# 2AM-WTP1826

## Technical Comment Responses

*Whale Tail Pit – Expansion Project*

Submitted to:  
**Nunavut Water Board**

**Figure ECCC-TC4-1. Annual Precipitation for Period of Record (Baker Lake A)**

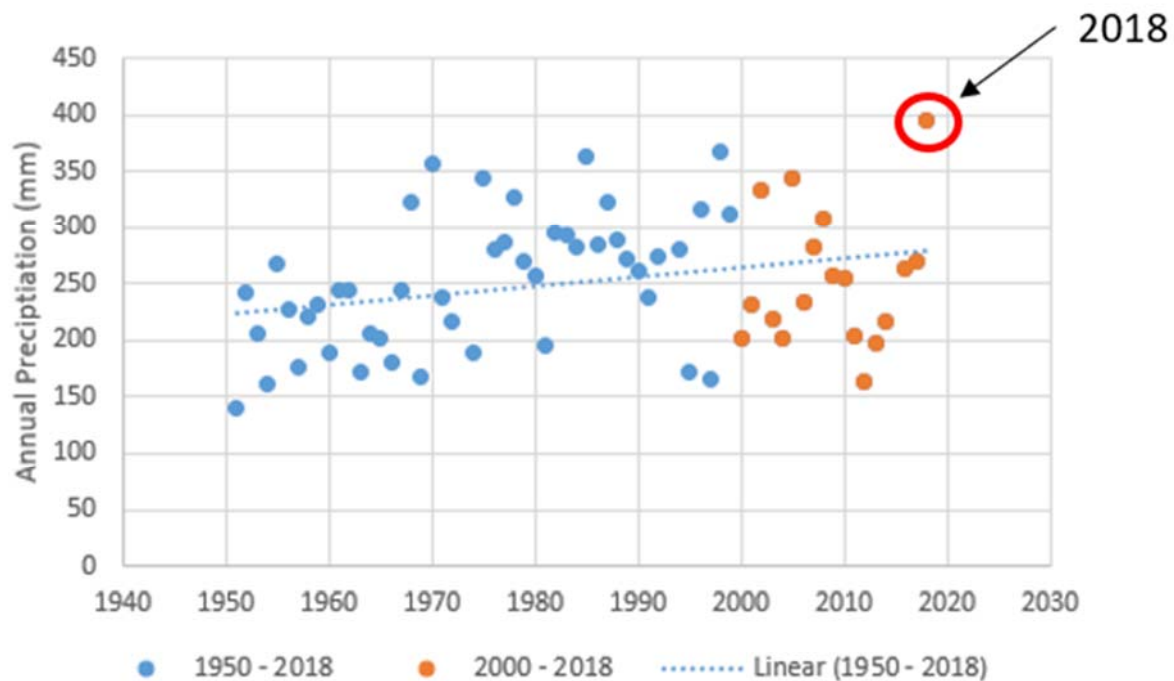
- *Identify the type, extent, timing and duration of water management issues associated with wet climate years that could potentially be encountered for the combined Approved Project and the proposed Expansion Projects.*
- *Clarify how the proposed mitigation measures would address the type, extent, timing and duration of potential water management issues associated with wet climate years for the combined Approved Project and proposed Expansion Projects.*
- *Update the Water Management Plan to incorporate the information requested above.*

Wet precipitation years corresponding to the 10-year and 100-year return periods were derived based on the daily precipitation record from the Baker Lake A Environment and Climate Change Canada (ECCC) Station (ID2300500) precipitation data (1950 – 2018). A frequency analysis was performed on the annual precipitation values derived from the dataset. The resulting annual precipitation is shown in Table ECCC-TC4-1 for the 10-year and 100-year return periods. Average precipitation statistics, available from previous studies (Agnico Eagle 2016), are also presented for comparison.

The precipitation was further corrected for undercatch, using a factor of 1.15 for rainfall and 1.55 for snow-water-equivalent, following previous studies (Agnico Eagle 2016). These factors were developed by ECCC to correct for underestimations of precipitation inherent to measurement limitations, particularly substantial in northern climates, as discussed by Mekis and Hogg (1999). The annual precipitation corrected for undercatch is also shown in Table ECCC-TC4-1.

Fig 1b

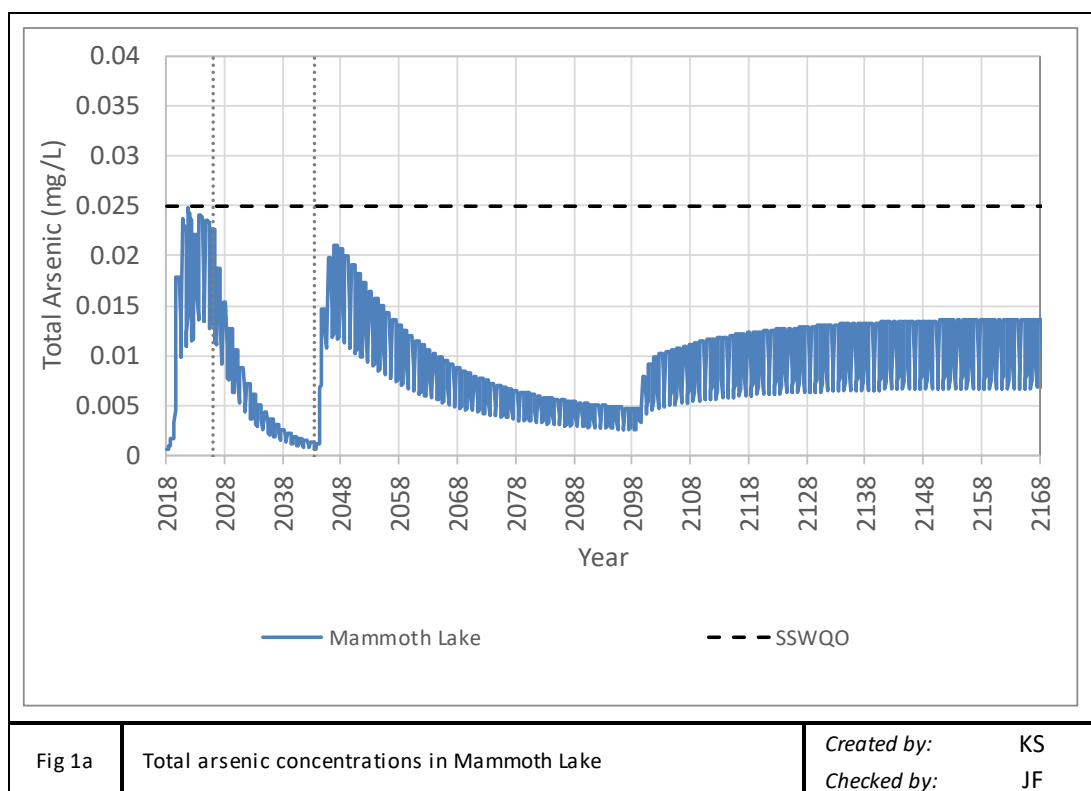
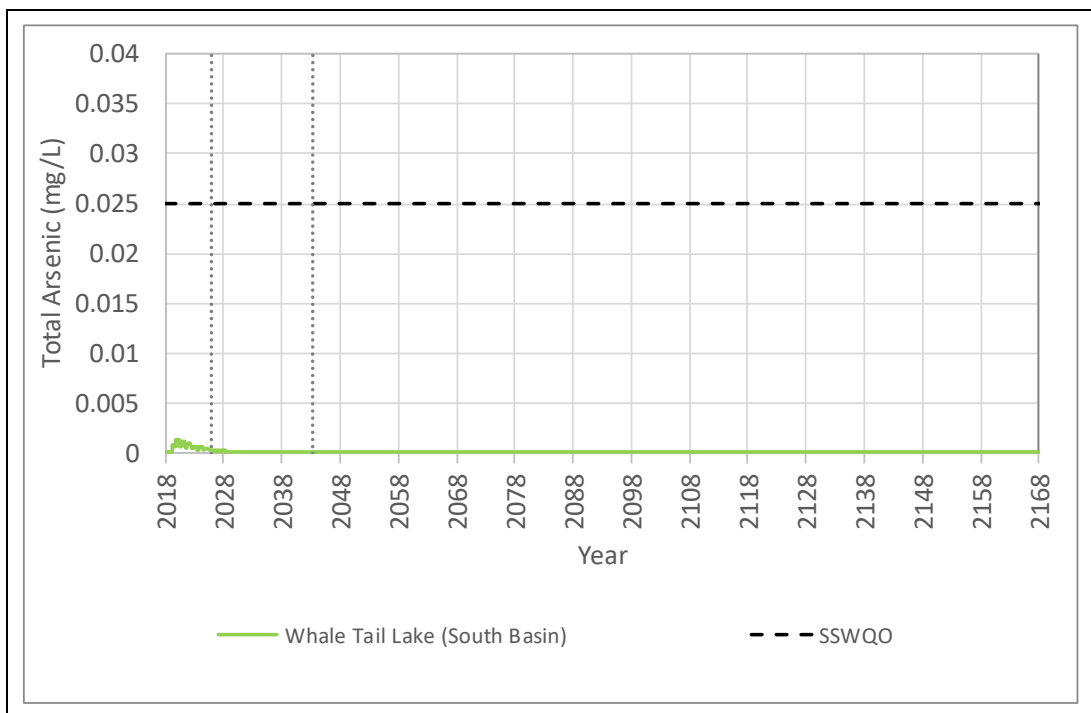
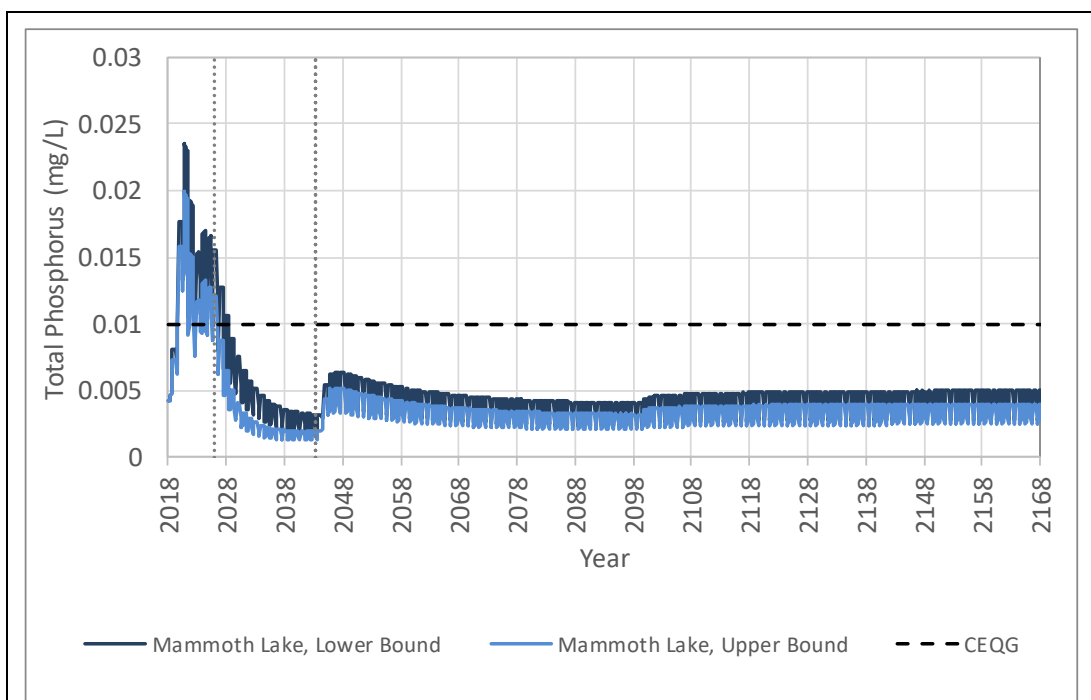
*Please update the water quality model to include cryo-concentration. This update should be provided as soon as possible but no later than 30 days prior to the public hearings to provide sufficient time for technical review*

The water quality model has been updated to include cryo-concentration; the model has also been updated to include biological phosphorus uptake rates and to include an updated effluent discharge plan. A description of the key assumptions for each of these updates are provided in the table below:

Predicted concentrations for total arsenic and total phosphorus in Mammoth Lake and Whale Tail Lake (South Basin) for the updated water quality modelling are shown below in Figures 1 and 2.
